**PROPOSED SOCIAL WELFARE FACILITY (RESIDENTIAL CARE HOME FOR THE ELDERLY) IN  
"VILLAGE TYPE DEVELOPMENT" ZONE ON APPROVED NAM SANG WAI OUTLINE ZONING  
PLAN NO. S/YL-NSW/10 AT LOTS 3670 RP (PART), 3671 RP (PART), 3672 RP (PART) AND 3673  
RP (PART) IN D.D.104, NAM SANG WAI, YUEN LONG**

**Town Planning Application No. A/YL-NSW/349 - Submission of Further Information (4)**

**Proposed Social Welfare Facilities (Residential Care Home for the Elderly (RCHE)) in “Village Type Development” Zone, Lots 3670 RP (Part), 3671 RP (Part), 3672 RP (Part), 3673 RP (Part) and adjoining Government Land in D.D.104, Nam Sang Wai, Yuen Long (TPB ref.: A/YL-NSW/349)**

**Response-to-Comment Table**

Title  
 LANDSCAPE LAYOUT  
 PLAN

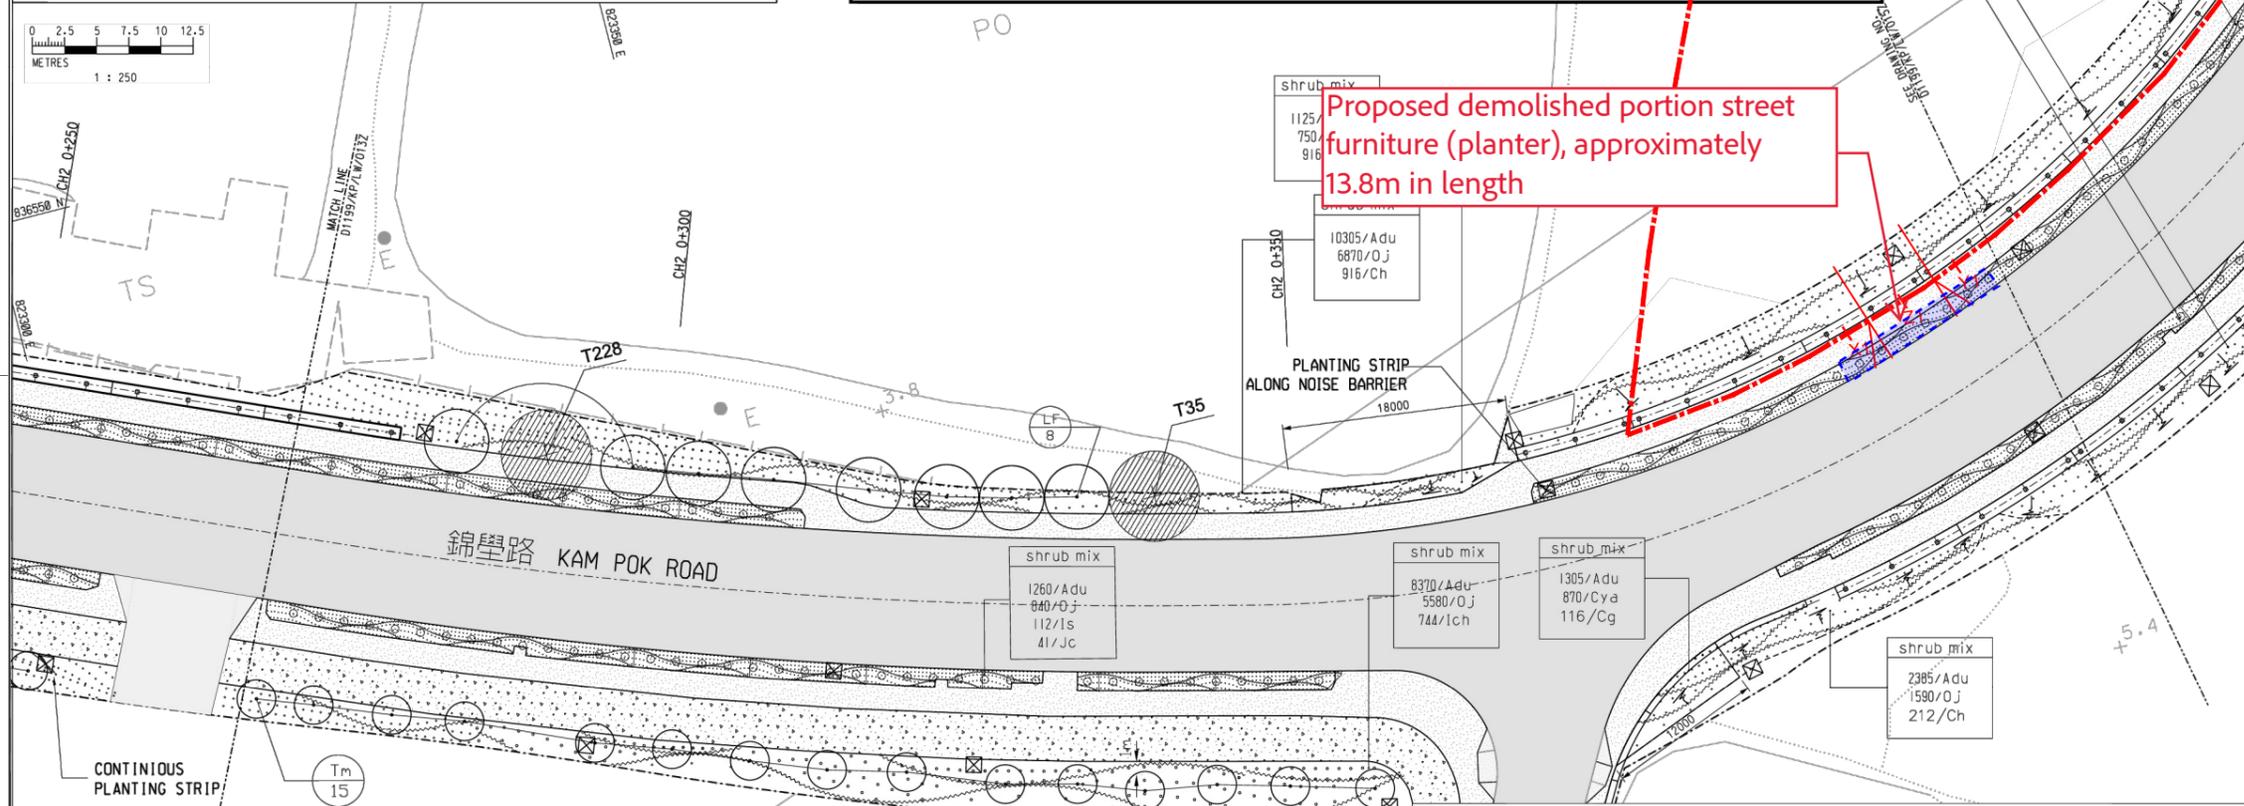
Departmental Comments	Response
<p><b><u>Email dated 21st October 2025 refers:</u></b>  <b><u>Comment from HyD</u></b></p>	
<p>2. Please find the following comments from highways maintenance point of view:</p>	
<p>(a) The relevant portions of noise barriers proposed to be removed have not been clearly indicated or marked on the modification plan. Please clarify.</p>	<p>Please refer to <b>Appendix 1</b> for the Modification Plans of Noise Barrier and Street Furniture.</p>
<p>(b) Responses to our comments given on 18 July 2025 have not been indicated in the R-to-C table. In particular, our comments on FI No.1 provided in Item 2(c) were not addressed in this submission. Please clarify.</p>	<p>The noise impacts due to the deletion of the existing noise barriers has been considered and assessed in the applicant’s Noise Impact Assessment. All related comments were addressed in the previous FI submissions and subsequently endorsed by the EPD. EPD has no further comments on the anticipated noise impact due to the modification or alteration to the existing noise barriers. Please refer to <b>Appendix 2</b> for the correspondence with EPD regarding noise impact.</p>

<p>(c) Please clarify whether the noise implications due to the deletion or removal of existing noise barriers have been assessed in the noise impact assessment, and agreed by EPD. Presumably, the Transport Department would comment on the traffic data adopted for the noise impact assessment under the construction and operation phase.</p>

Proposed demolished portion street furniture (planter), approximately 13.8m in length

**FIGURE 3**  
**PROPOSED TERMINAL MANHOLE AND**  
**CONNECTION**

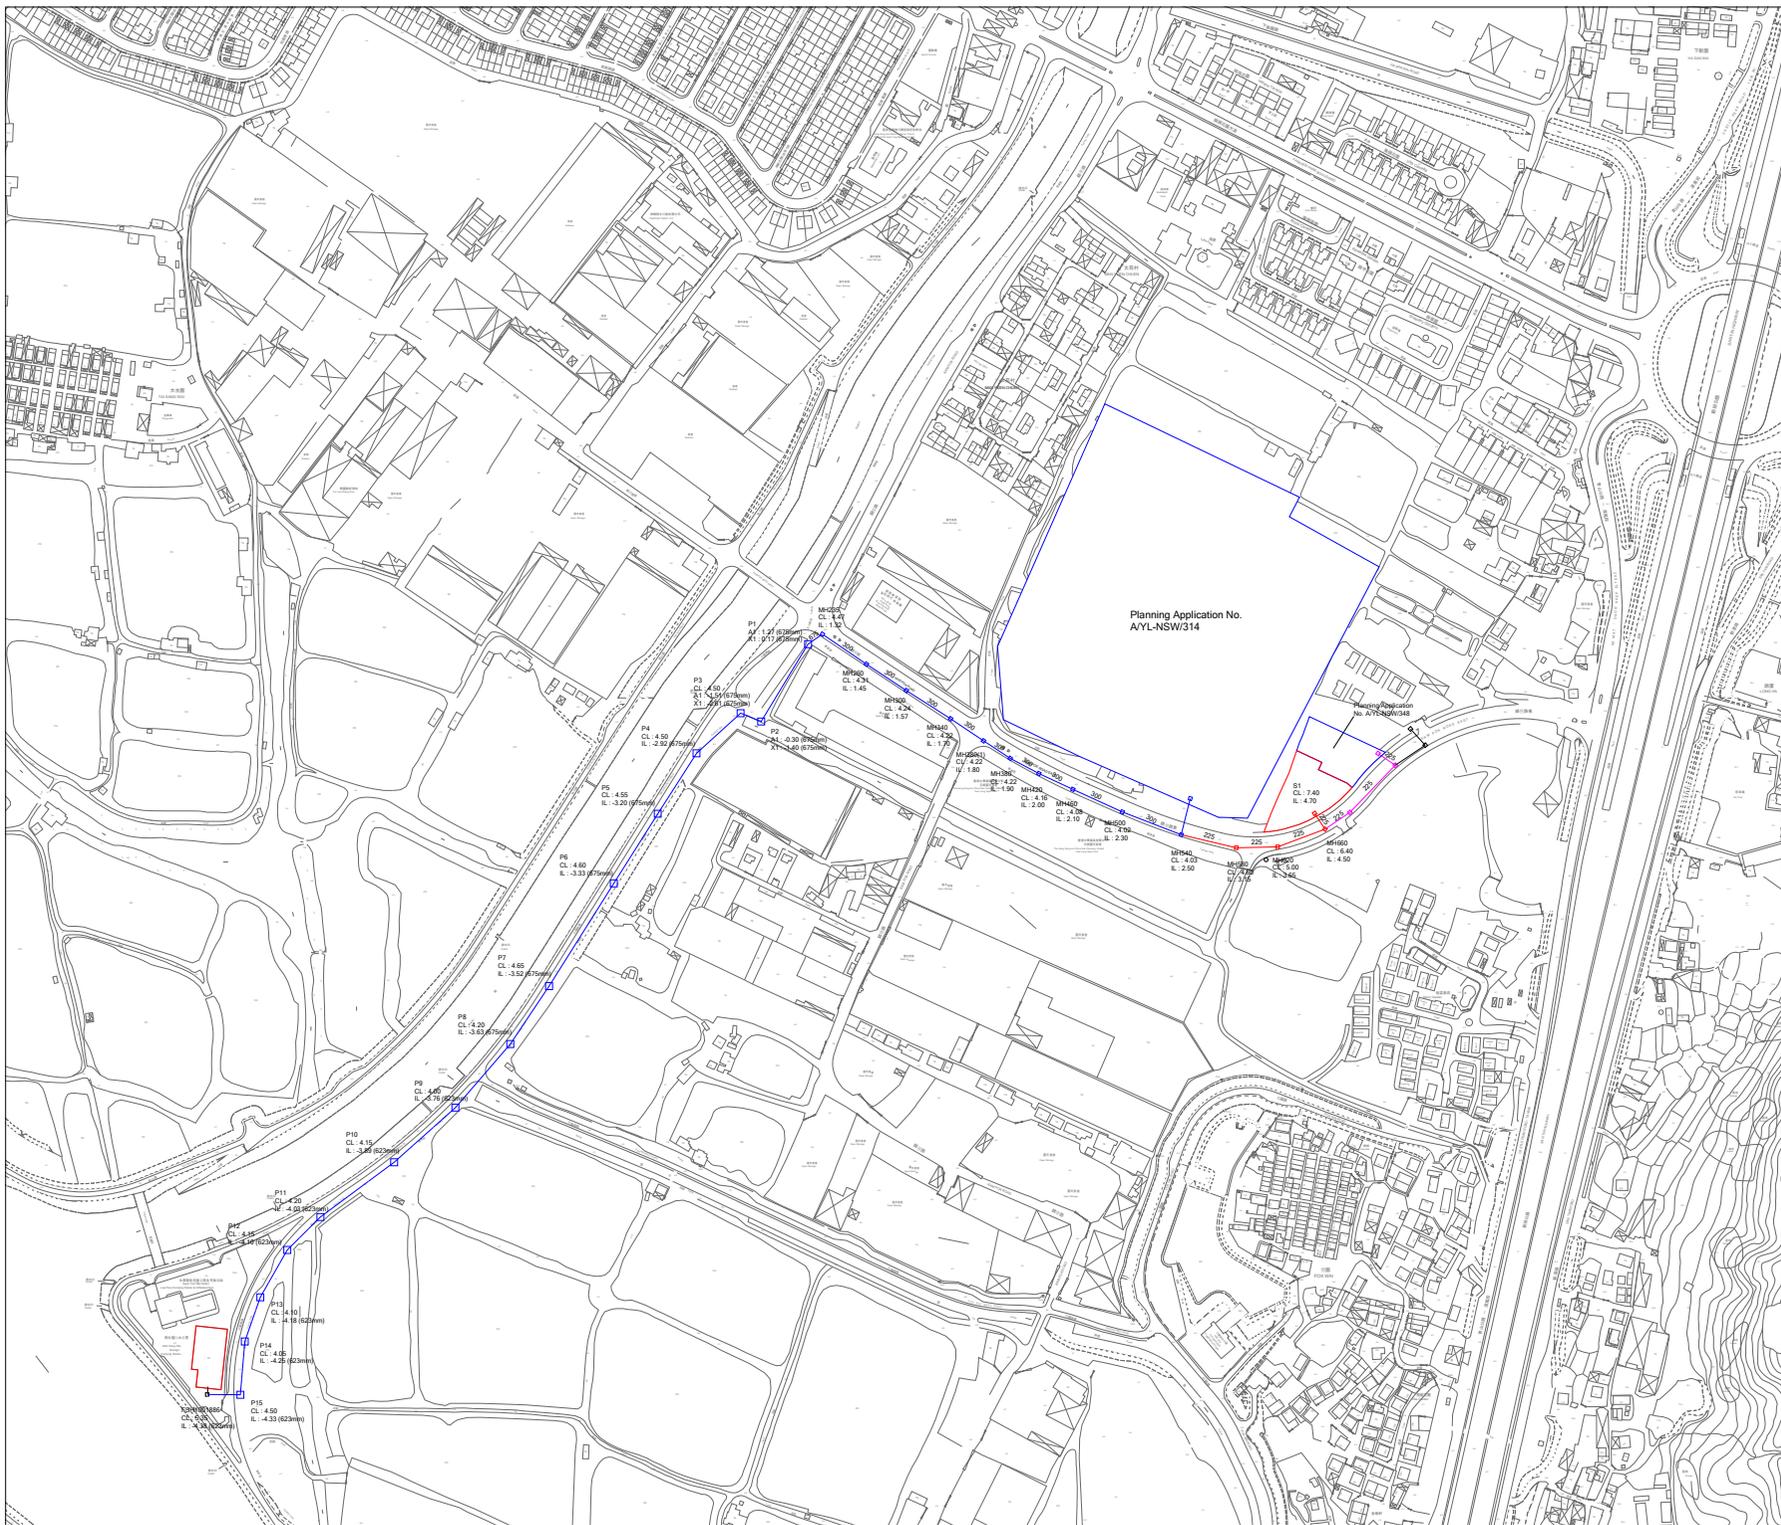
4. Section 2.4.1 – a. Please revise as “New terminal manhole (namely S1) and manholes MH660, MH620 and MH580 will be constructed to collect..” b. Please revise “connect to the communal sewer” as “connect to manhole MH540”.	The Section is revised accordingly.

2.4.1. **New terminal manhole (namely S1) and manholes MH660, MH620 and MH580 will be constructed to collect** the sewage generated from the Proposed Development and **connect to manhole MH540** via a new 225mm diameter sewer pipe. The location of the proposed connection are shown in **Figure 3**. The cover level of proposed terminal manhole should be higher than that of the downstream public manhole(s). The proposed new terminal manhole and 225mm sewer pipe within site boundary will be implemented and maintained by the Project Proponent, other proposed manhole and sewer outside site boundary will become a public sewage system serving multiple users and will be handed over to government for future maintenance. The capacity check of the sewer will start from the proposed terminal manhole S1. The proposed
